WELLINGTON CITY COUNCIL

Report and Recommendations of Independent Commissioners

Hearing Stream 4

**Metropolitan Centre Zone (including DEV1 Kilbirnie Bus Barns)
Local Centre Zone
Neighbourhood Centre Zone**

Figure 1: Requested 50 metre Height Area for Johnsonville MCZ

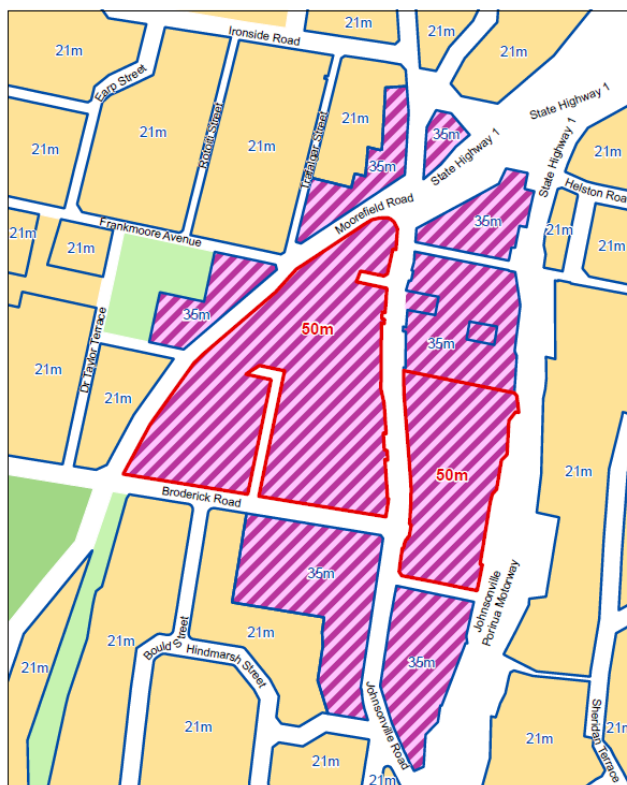
136. Investore and Stride¹³¹ were generally supportive of the 35 metre height limit in MCZ-S1, but considered that it is important that the MCZ has suitable building heights to enable sufficient development capacity. The submitters requested a two-tier approach in Johnsonville, as with Kilbirnie, and requested a 50 metre height limit for an identified area between Moorefield Road and the Johnsonville-Porirua Motorway, as shown below:

147. In Reply, Ms Hayes disagreed with Kāinga Ora for the reasons set out in paragraphs 52-58. She did change her mind and agreed that an increase in height to 42 metres is appropriate centrally within the Johnsonville MCZ – the area is outlined in red as shown in the map above at paragraph 136. She also agreed to an increase in height for Kilbirnie to 35 metres for consistency. We support her recommendations to increase the height for both Johnsonville and Kilbirnie for the reasons set out in her Reply. Regarding Johnsonville, we can see no reason why the area east of Johnsonville Road and south of Disraeli Street has been excluded.
